NUMBER: 25-001-07

I/M Readiness Check Continues To Indicate OBD System Is Not Ready For I/M Testing

This bulletin involves modifying wiring in the Power Distribution Center (PDC).

2005 - 2006 (TJ) Wrangler

Fig. 1 TWO 20 GA. PK/WT WIRES - A13

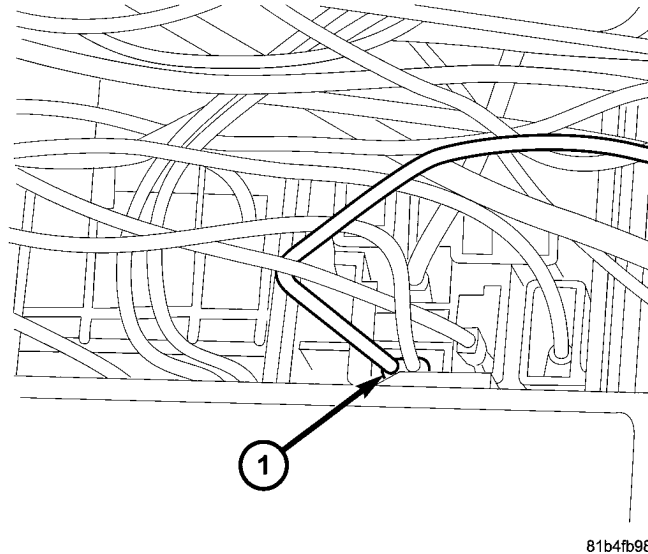
1 - TWO 20 GA. PK/WT WIRES - AT PDC CAVITY A13 (FOR ASD RELAY PIN 85)

Fig. 2 CUT ASD 20 GA PK/WT TO FUEL PUMP

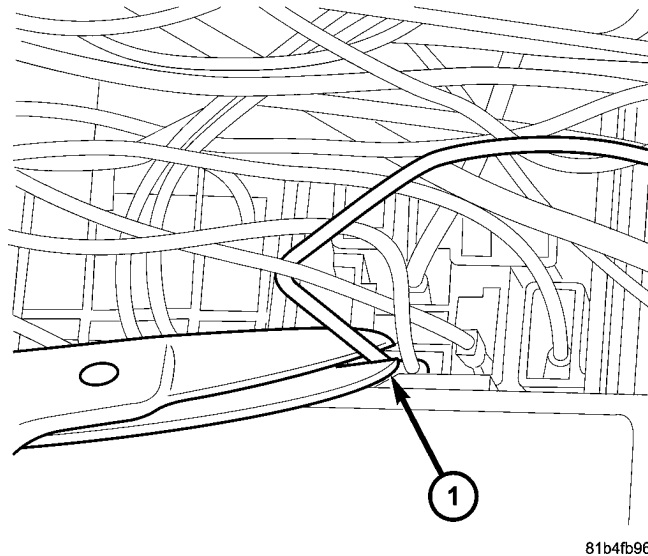
7. At PDC cavity A13 (ASD), locate the one PK/WT wire that connects to the fuel pump relay terminal.
8. Cut the PK/WT wire, that connects to the fuel pump relay, as close to the PDC cavity A13 terminal as possible, (Fig. 2).

1 - CUT PDC CAVITY A13 PK/WT WIRE THAT GOES TO THE FUEL PUMP RELAY CLOSE TO TERMINAL

Fig. 3 CUT ASD 18 GA. RD/YL WIRE - A15

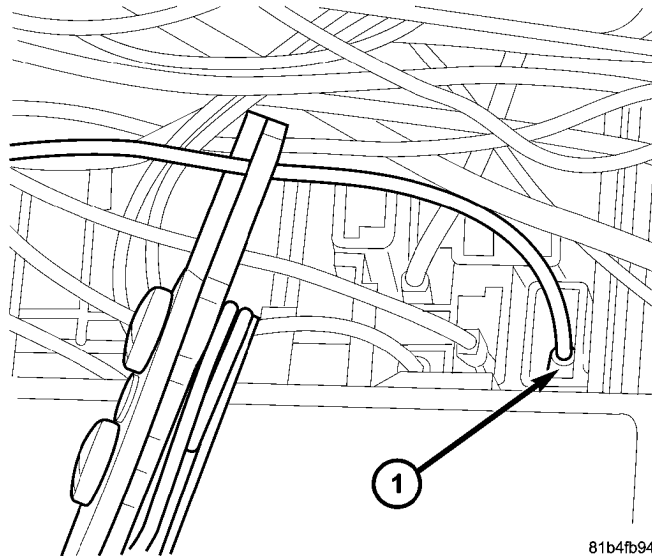
12. Locate the RD/YL 18 gauge wire connected to the terminal end in PDC cavity A15. This wire connects the ASD relay pin 30 to fuse #9 (ASD power) in the PDC.
13. Cut this wire approximately 2 inches from the PDC cavity A15 terminal (ASD relay pin 30) ([Fig. 3](#)).

1 - CUT PDC CAVITY A15 18 GA. RD/YL WIRE THAT GOES TO ASD RELAY PIN 30 TWO INCHES FROM TERMINAL

Fig. 4 COMPLETED WIRE SPLICES

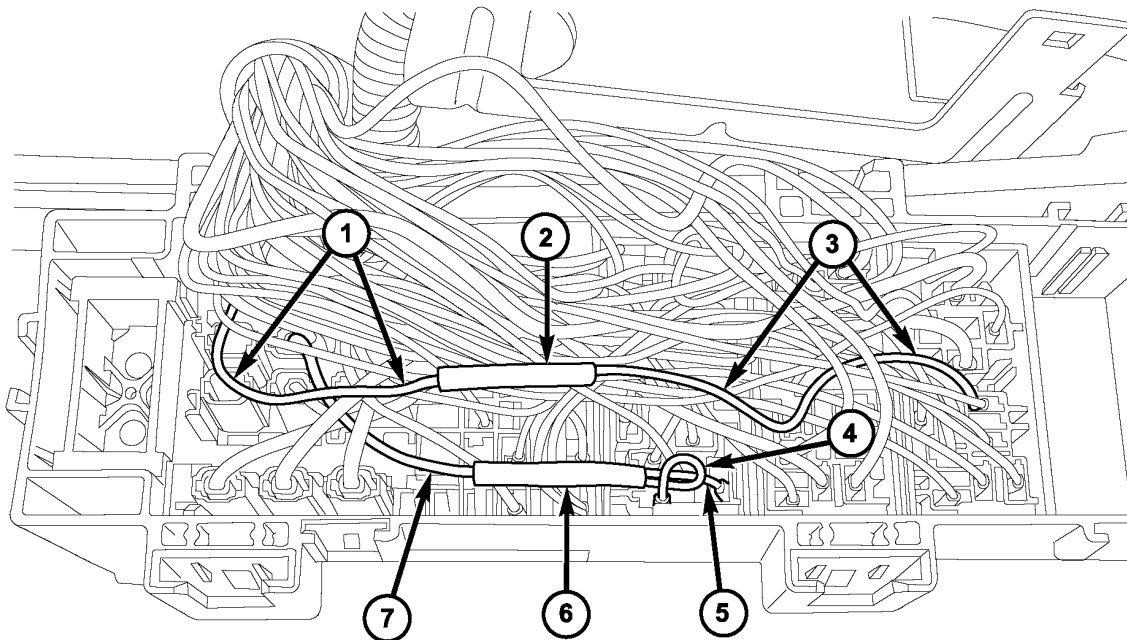
-
14. Strip approximately 0.25 inches of insulation from both ends of the RD/YL wire cut in Step #13.
 15. Splice the two RD/YL wires to the one remaining PK/WT wire (2 inch lead at A13) together ([Fig. 4](#)). **Be sure to slide shrink tube over wire before crimping.** Splice the wires with kit p/n 05018395AA.
 16. After both splices are complete, solder crimp splices with non-acid core solder.

17. Slide shrink tube over soldered splices and shrink with a heat gun until sealant is visible on both ends of the splice ([Fig. 4](#)).

- 1 - 20 gauge PK/WT wire from wire harness bundle with convolute
- 2 - Splice repair (2 wires)
- 3 - 20 gauge PK/WT wire from fuel pump relay
- 4 - 20 gauge PK/WT wire from PDC cavity A13 for ASD relay pin 85
- 5 - 18 gauge RD/YL wire from PDC cavity A15 for ASD relay pin 30
- 6 - Splice Repair (3 wires)
- 7 - 18 gauge RD/YL wire from PDC fuse #9 for ASD power
